**SUMMARY OF THE NRC/DOE TECHNICAL EXCHANGE ON THE
DRAFT STAFF TECHNICAL POSITION ON "GEOLOGIC REPOSITORY
OPERATIONS AREA UNDERGROUND FACILITY DESIGN -- THERMAL LOADS"**

March 17, 1992
Albuquerque, New Mexico

As a focus for the discussions, the NRC staff relied upon a draft comment response package (designated "REV 0") it had prepared as part of the development of the final STP. The comment response package contains the staff's proposed responses to the public comments it had received on the July 1991 public comment draft of the STP. (Unlike the version distributed at the technical exchange, the comment response package attached herein (designated "REV 1") has been revised to reflect comments received from NRC's technical editor (see attachment 3). However, no substantive revisions have been made to the responses themselves.)

FIGURE 1 -- The Logic Flow for an Example of an Acceptable Methodology for Demonstrating Compliance with 10 CFR 60.133(i). The numbers next to the process blocks refer to the steps necessary to implement technical position 3.1. These steps are described in Sections 3.0 and 4.0 of the text.

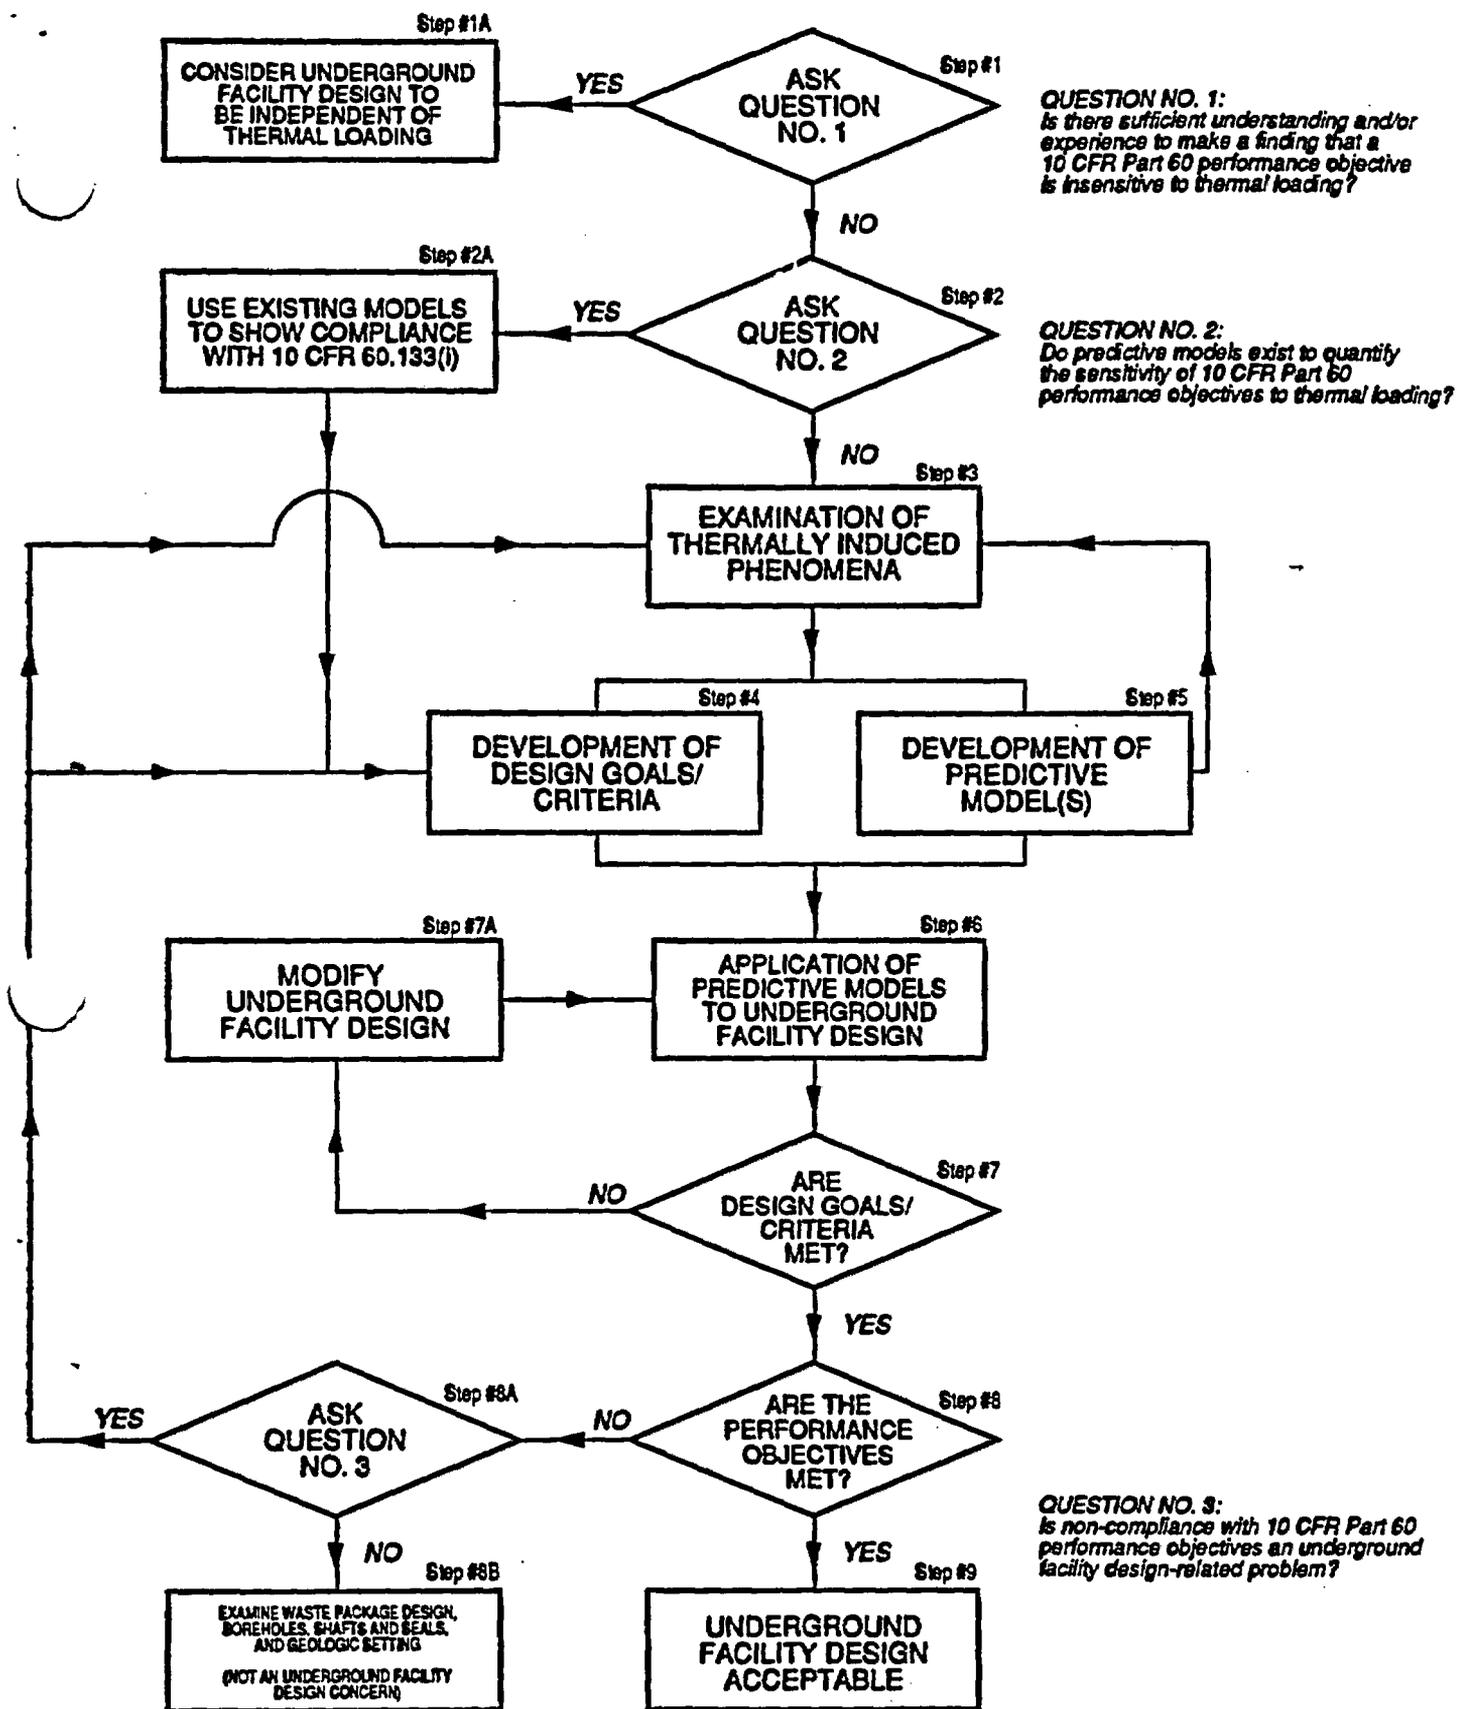
Steps two and four should be reversed. Step two would use existing models to show compliance with 10 CFR 60.133(1), and step four would develop design goals/criteria for the underground facility. Even if the existing models were adequate, they cannot be used to show compliance until after design goals and criteria are developed. Later, the STP says the same, "The purpose of developing design goals/criteria... is ... to contribute to the assurance that the design of the underground facility has the likelihood of meeting these performance objectives" (pages 14 - 15).

Step No. 3 needs to be clarified since it is not apparent if "defensible models" used in Step No. 3 are in fact those "existing models" that will show compliance with 10 CFR 60.133(i), as illustrated in Step No. 2A, Figure 1.

The second paragraph states, "As illustrated in Figure No. 1, the process may be terminated at different decision points, depending on the state of the knowledge and complexity of the information needs."

Other than the first step, Figure 1 does not indicate decision points at which the process may be terminated. Either add these decision points or do not say that they are present.

28. Page 25, Figure 1

The staff disagrees with DOE's recommendation that Step Nos. 2 and 4 in Technical Position 3.1 should be reversed. The STP text for Step No. 2 states that if reliable predictive models exist, they should be used, and the process proceeds directly to Step No. 4, the development of design goals/criteria (i.e., bypassing Step Nos. 3 and 5). This logic flow is shown in Figure 1. Step No. 2A was included to indicate this alternative path. Thus, Figure 1 shows that compliance with 10 CFR 60.133(1) is facilitated by first developing design goals/criteria for the underground facility.

Because there is no activity per se associated with Step No. 2A, the staff has decided to remove Step No. 2A in Figure 1, without altering the "yes" exit path from Step No. 2. In addition, the iterative process indicated by the return from Step No. 5 to Step No. 3 has been changed to indicate an iteration between Step Nos. 5 and 2. The latter change was made so that the approach includes an explicit check of the adequacy of the models as they are developed.

The staff agrees that the flow logic shown in Figure 1 for Technical Position 3.1 does not indicate any decision points for termination of the process other than the first step. Consequently, the 5th paragraph of Section 4.1 ("Discussion") has been deleted from the STP.

Regarding the first portion of this comment, DOE is referred to the last paragraph of Step No. 8, under Section 4.1 ("Discussion"), where a discussion is provided of what takes place beyond Step No. 8B.

Regarding the second portion of DOE's specific comment concerning what drives Step No. 7A (e.g., the need to modify the underground facility design), Step No. 7A will result if there is noncompliance with the design goals/criteria evaluated in Step No. 7. For example, if a goal/criterion exists for a maximum borehole wall temperature, and this criterion is exceeded as a result of either a very high initial power output from the waste package, or very close spacing between emplacement boreholes, this would result in a "visit" to Step No. 7A. Once the underground facility design is modified, as shown in Step No. 7A, the iterative process returns to Step No. 6.

The staff agrees with the State of Nevada comment regarding the need to revisit Step No. 2, and has modified the recommended approach accordingly. The modification involves a return from Step No. 5 to Step No. 2 in Figure 1. In addition the text for Step No. 5 has been changed in Technical Position 3.1.

FIGURE C1 -- Example of an Iterative Process for the Analysis of Thermally Induced Phenomena Based on One-Way Coupling.

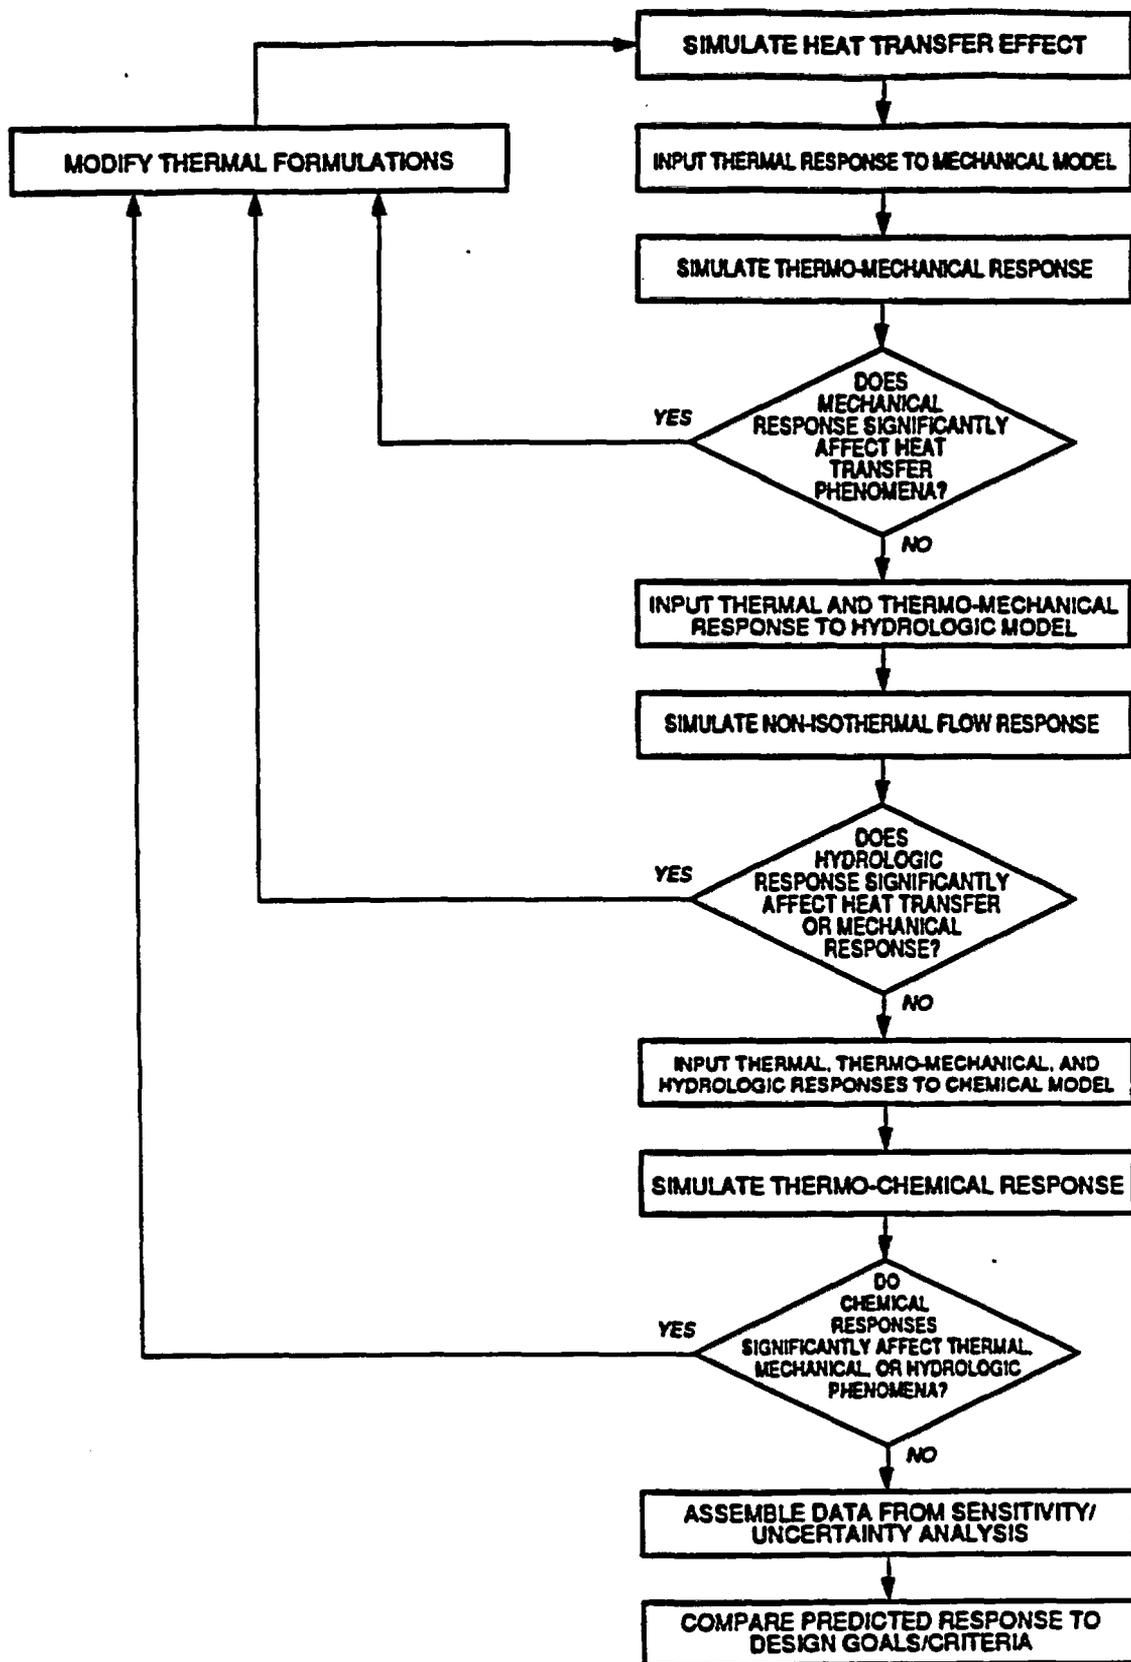
- **Need for evaluating alternative orders of consideration for Figure C1 and demonstrating the basis for selection**
- **Word "licensee" should not be in the STP.**

- **The order selected should be demonstrated to be the most appropriate.**
- **The staff agrees and the term "licensee" has been replaced by "DOE."**
